## Plan Review Discrepancy Report Reply Letter

Sequoia Orchard Park, Lee's Summit, MO Permit # PRES20240700

**SEQUOIA DUPLEX ALT #1**  
**205 & 207 Orchard Court**  
**LEE'S SUMMIT, MO**

SP-1

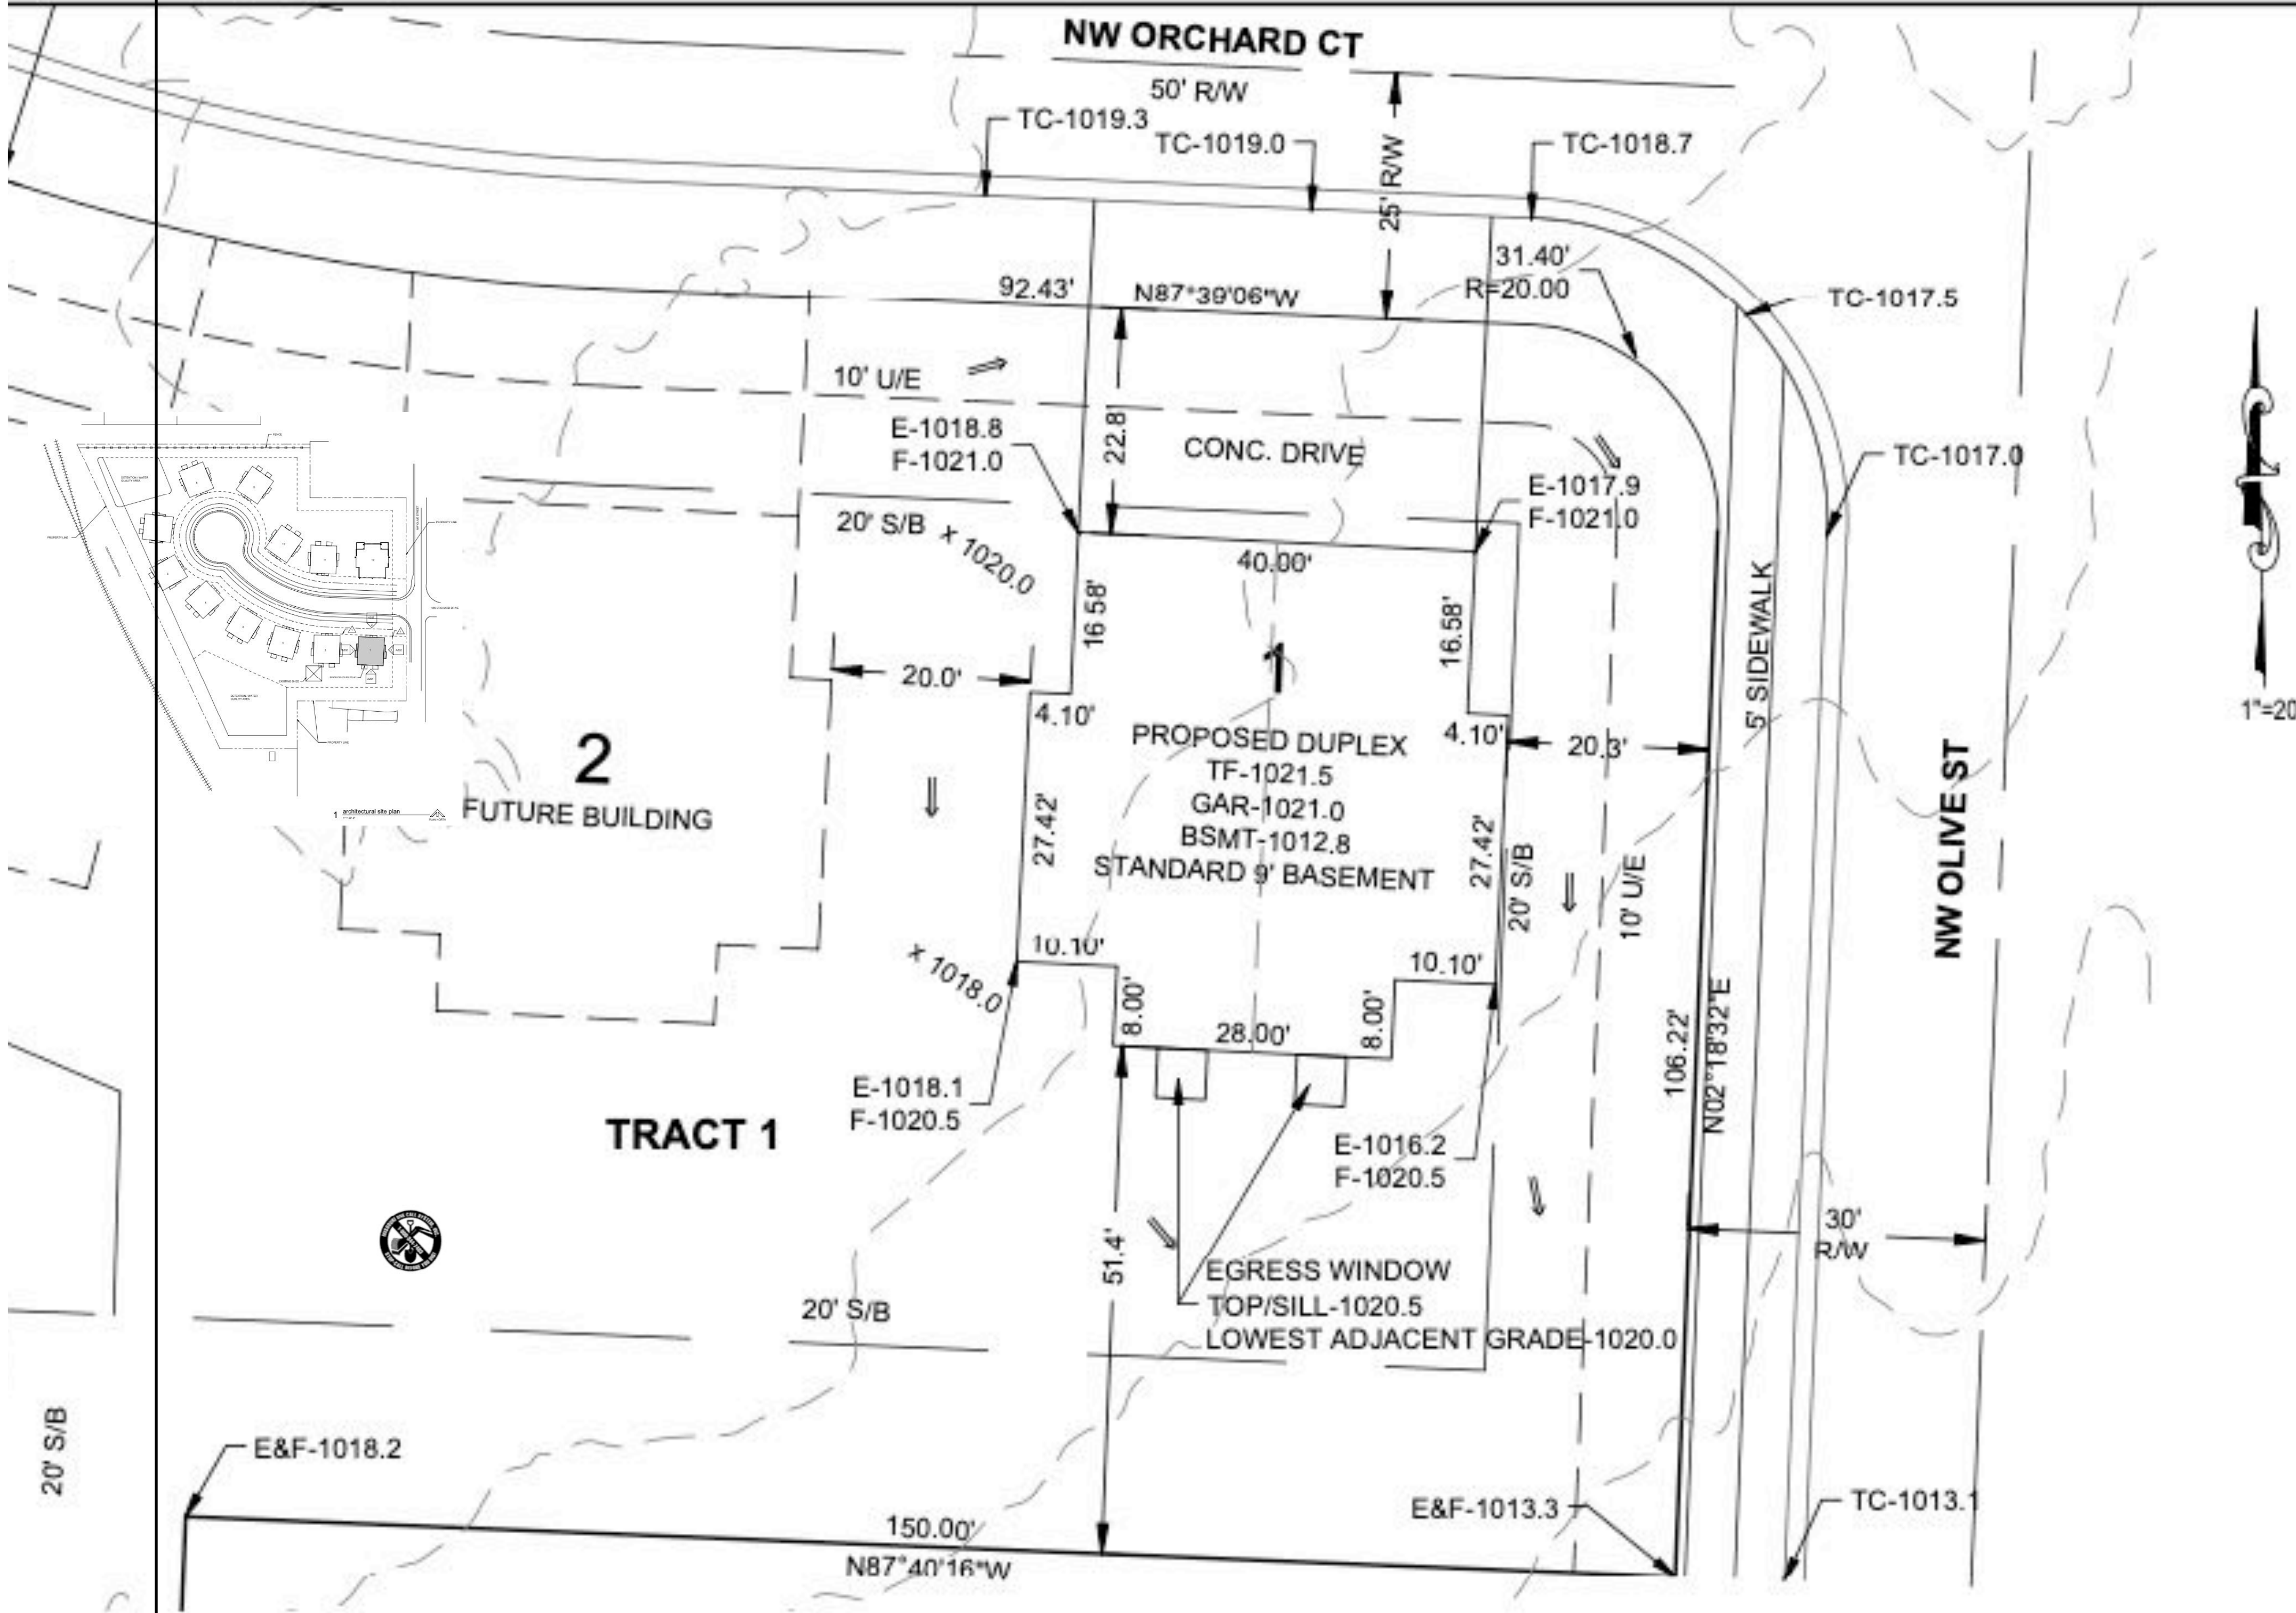
**ITEM #1** I have added the proper plot plan that you send me on a SP-1 Sheet. With additional information on that sheet.

**A102**

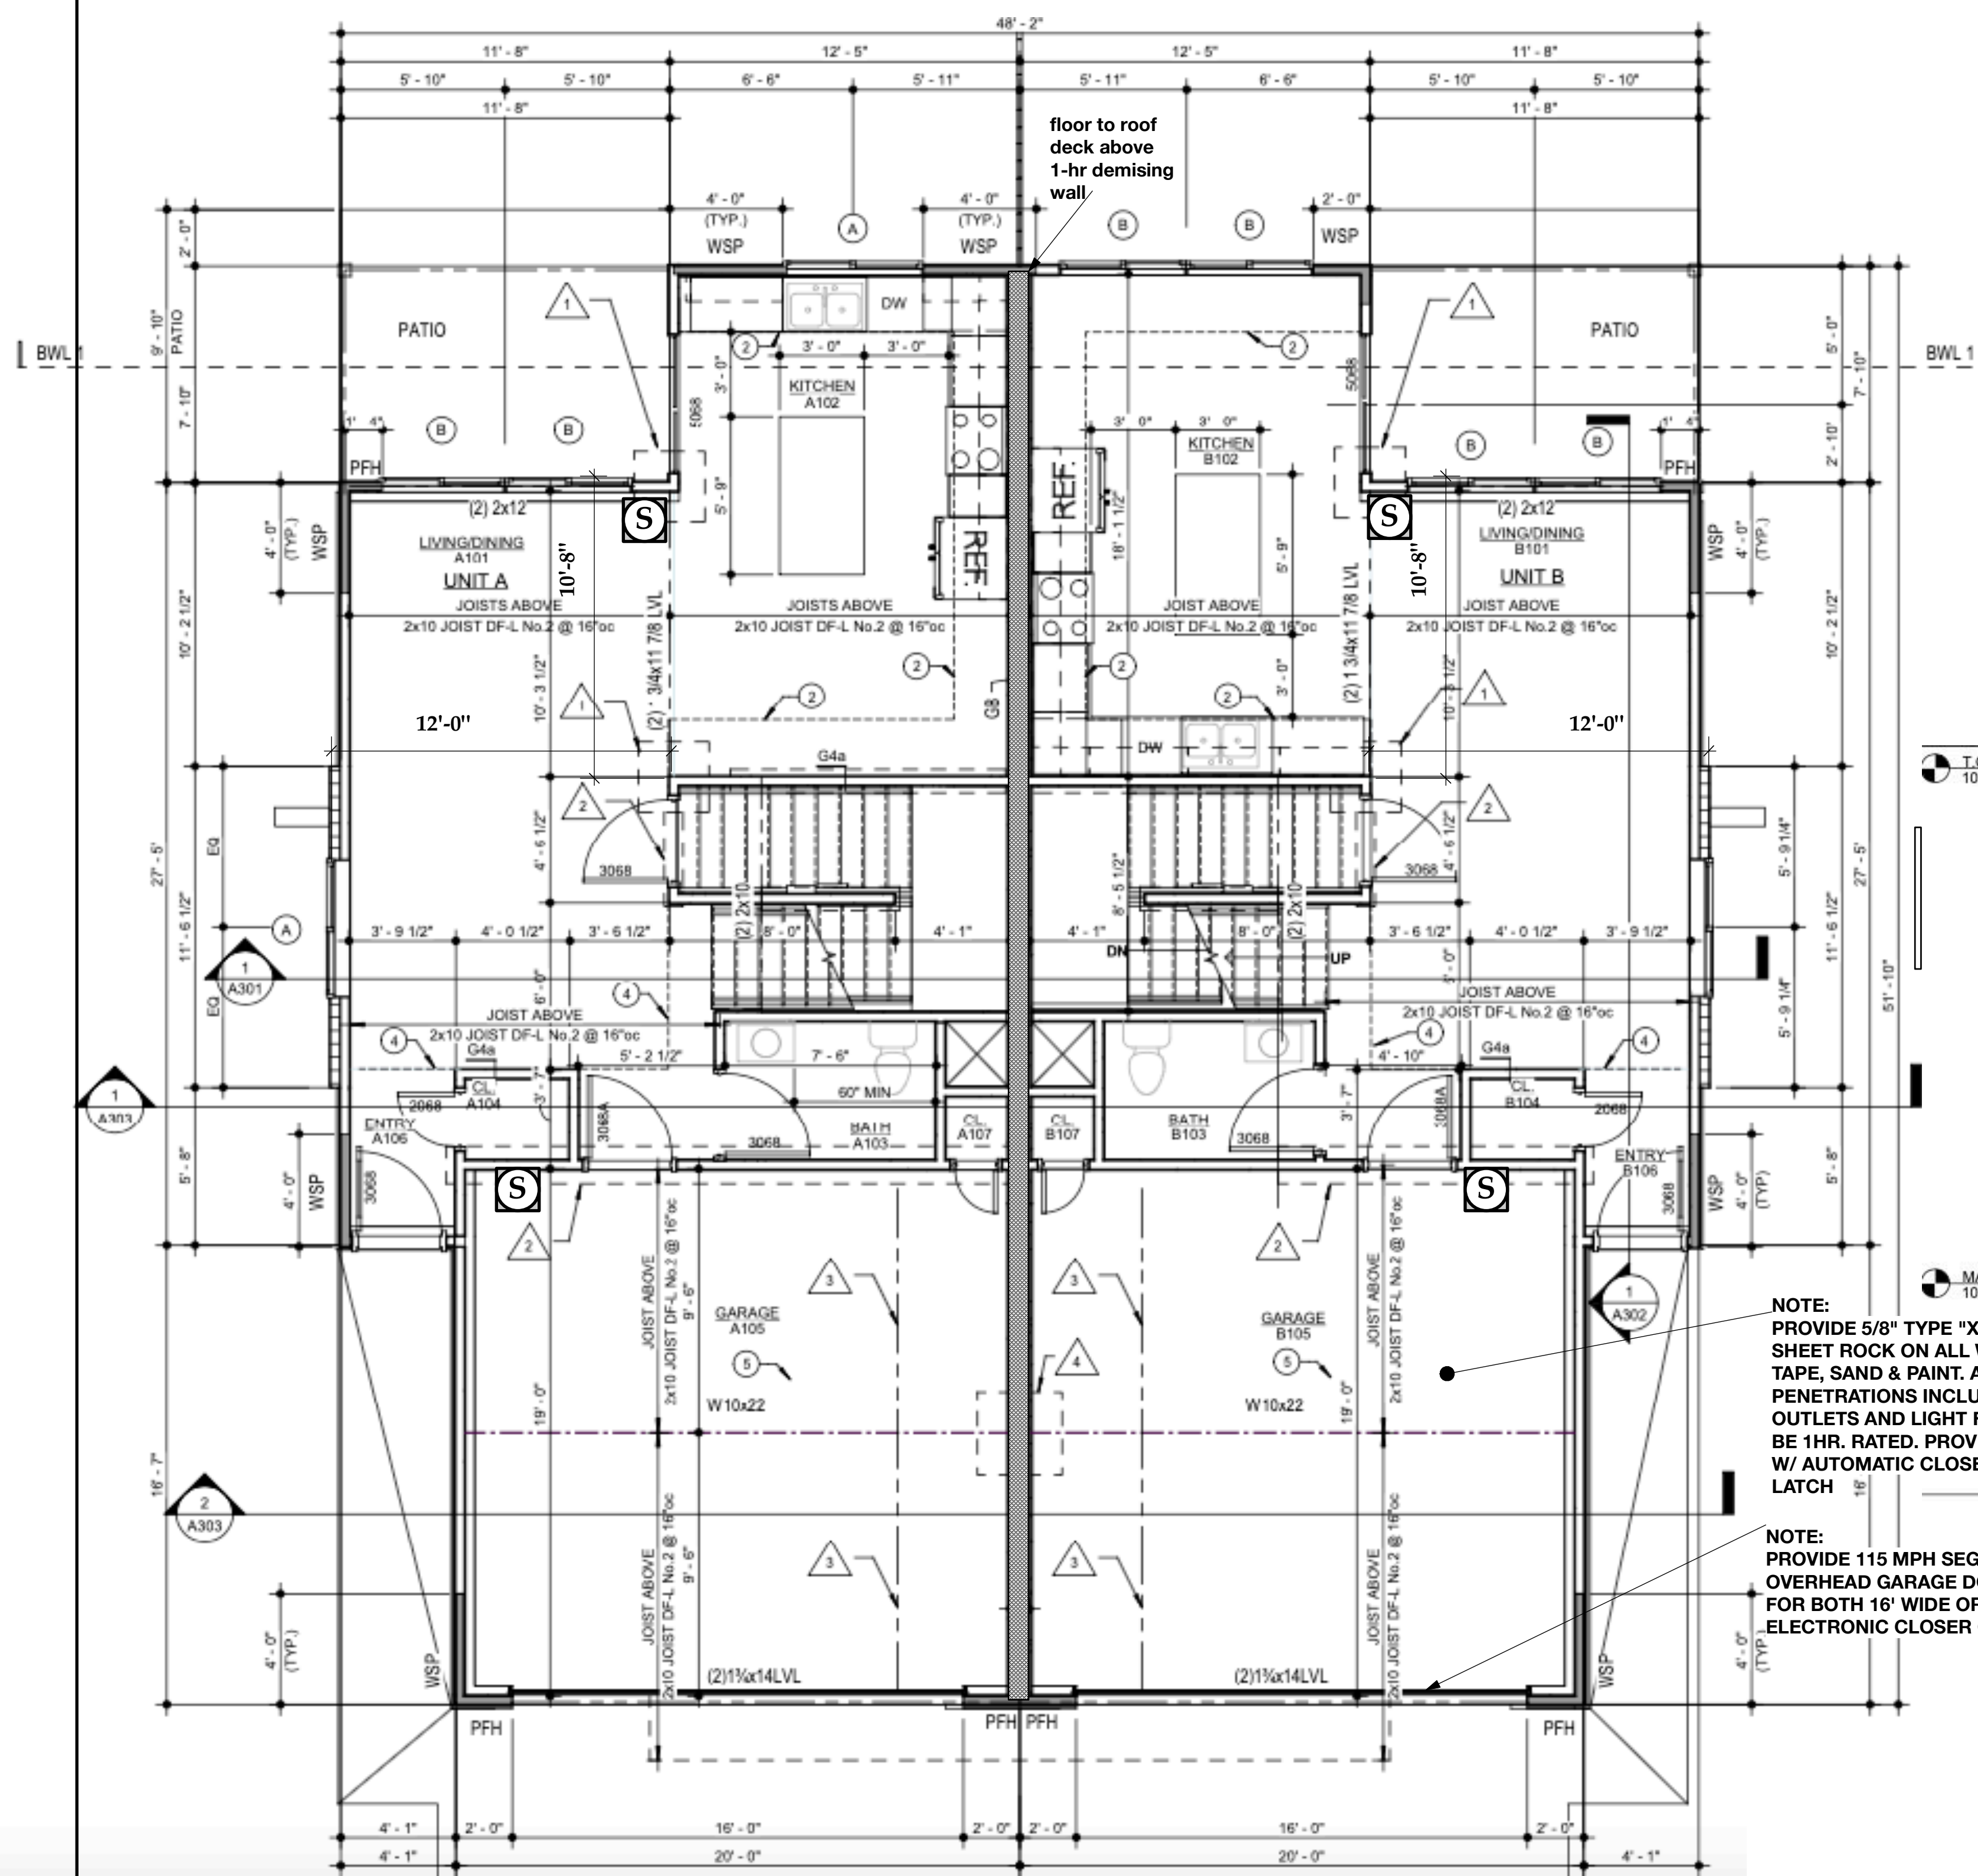
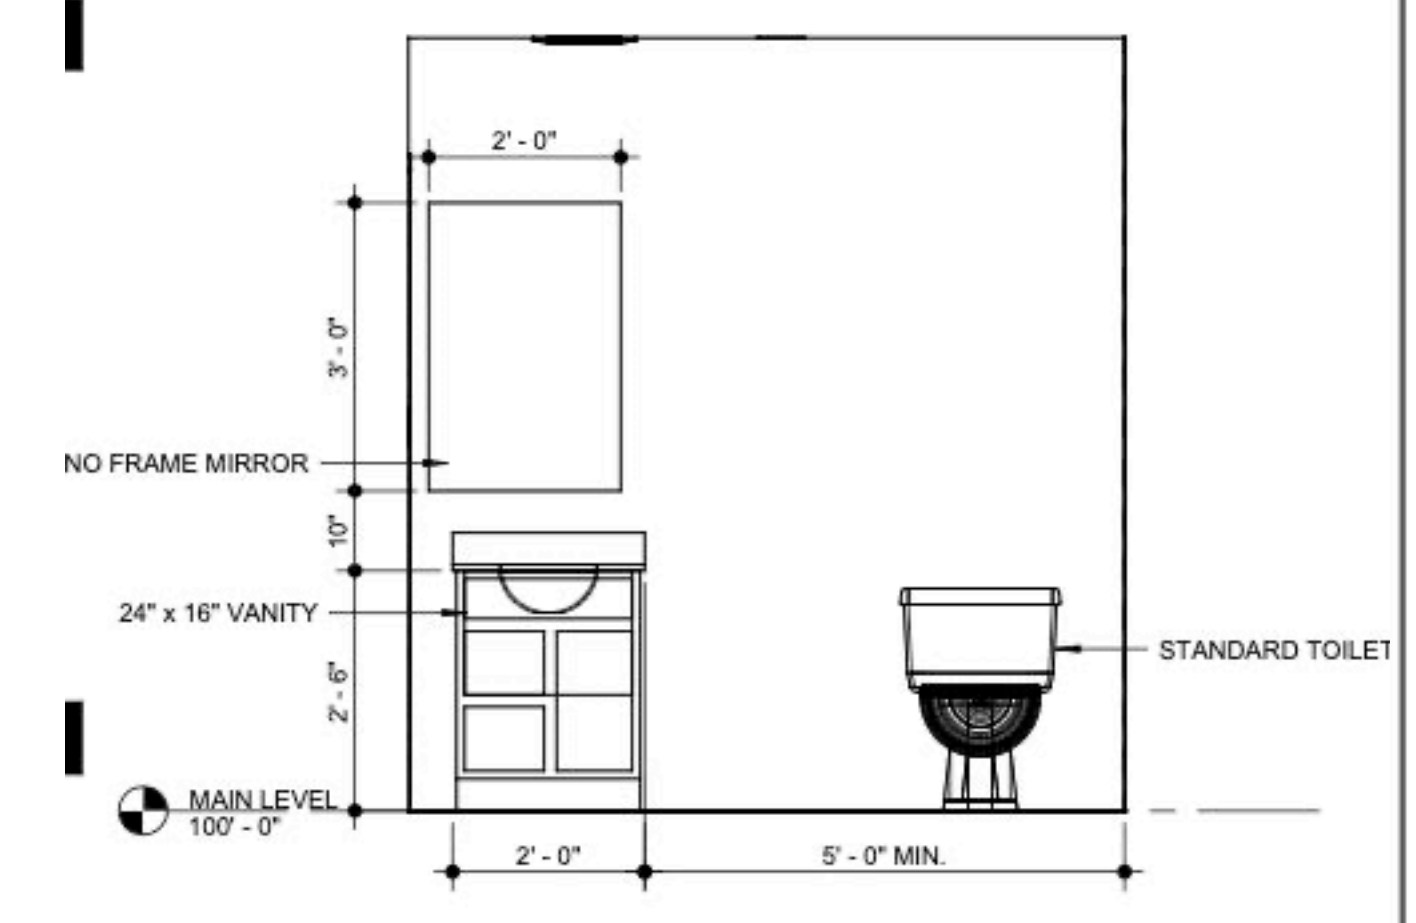
**ITEM #1** The square footages are placed on the top of sheet A102 and are in both Gross and Net areas and I am sending an updated Application Form that will match the areas together from what the final plans show.
